From: Mark Semmelmeyer [mws@ghidra]
Sent: Tuesday, November 01, 1994 8:58 AM
To: 'Jeff Marr'
Cc: 'euterpe@ghidra'
Subject: 4 bit group ops

From: Tim B. Robinson [tbr@aphrodite]
Sent: Wednesday, November 02, 1994 12:53 AM
To: 'euterpe@aphrodite'
Subject: FINAL DECISION: 4bit add/mpy/set

From: Jay Tomlinson [woody@luckboy]
Sent: Thursday, November 03, 1994 11:28 AM
To: 'euterpe@luckboy'
Subject: IMMINENT Decision: instruction cache tag bit change

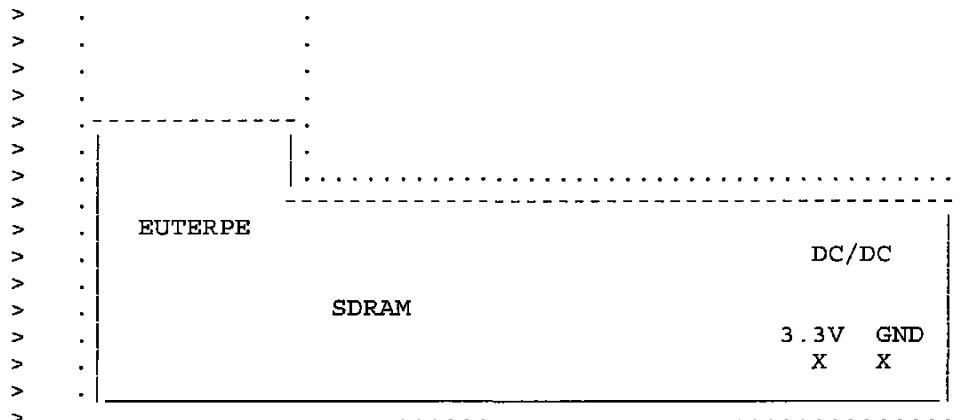
At 1:22 PM 11/11/94 -0800, Jean-Yves Michel wrote:
>Here is the latest proposal, pending a final OK from Tom and Philip on
>the pcb stack-up:
>we will have 2 seperate power/gnd planes, one for Euterpe and the SDRAM
>and one for Calliope and peripherals. The calliope planes will be
L-shaped
>and the other one will be closer to a rectangle.

>There will be a small supply voltage difference between euterpe and
>calliope due to IR drop but the differential interface should not be
affected.

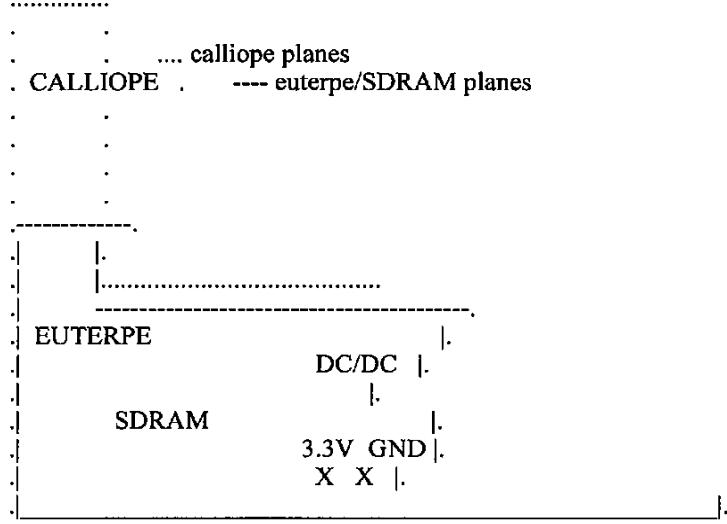
I now understand that it has been decided to change the resistor code on euterpe from a value of 5 to 6. Although I haven't seen any discussion of this decision, I assume it is to help meet the speed targets. However, I should point out that the custom blocks, and particularly the cache were designed at resistor code = 5 and were not simulated at higher values. While I don't have particular concerns regarding functionality, I should point out that at least in the cache, power bus wiring was extremely tight and that the currents used for sizing the busses for IR drops and more importantly for electro-migration were based upon a resistor code of 5. Increasing the code to 6 will likely cause some power busses to exceed their EM limits by the percentage power increase (20%?).

We are investigating this change as a way to reduce the atom count while maintaining the cycle time. There is no reason to change the knob setting for the custom structures. By adjusting the knobs for the SOFA we get the same speed from smaller cells and so can increase density.

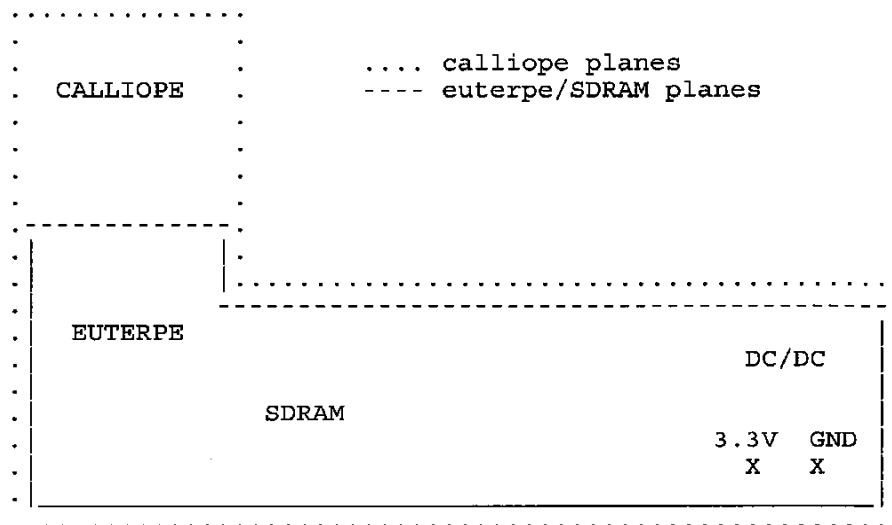
outside the outlined area, the 4 internal layer will be used differently to carry power (3.3, 5 and 12V), current carrying ground planes, shields and chassis ground planes.

If you have any objection, raise your voice immediately. A lot of layout will be done this week-end, so the power plane scheme should be finalized by the end of the day.

Looks good to me.

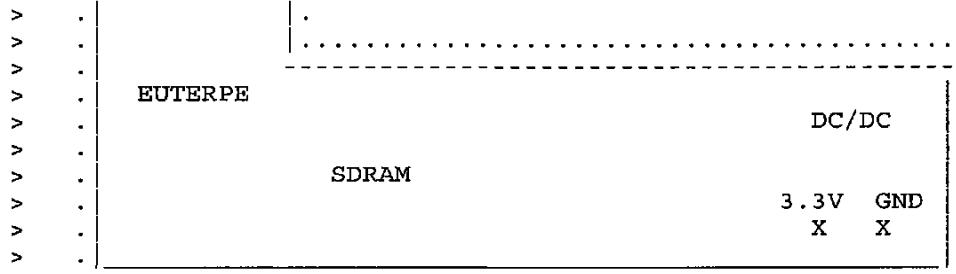
At 1:22 PM 11/11/94 -0800, Jean-Yves Michel wrote:
>Here is the latest proposal, pending a final OK from Tom and Philip on
>the pcb stack-up:
>we will have 2 separate power/gnd planes, one for Euterpe and the SDRAM
>and one for Calliope and peripherals. The calliope planes will be
L-shaped
>and the other one will be closer to a rectangle.

>There will be a small supply voltage difference between euterpe and
>calliope due to IR drop but the differential interface should not be
affected.
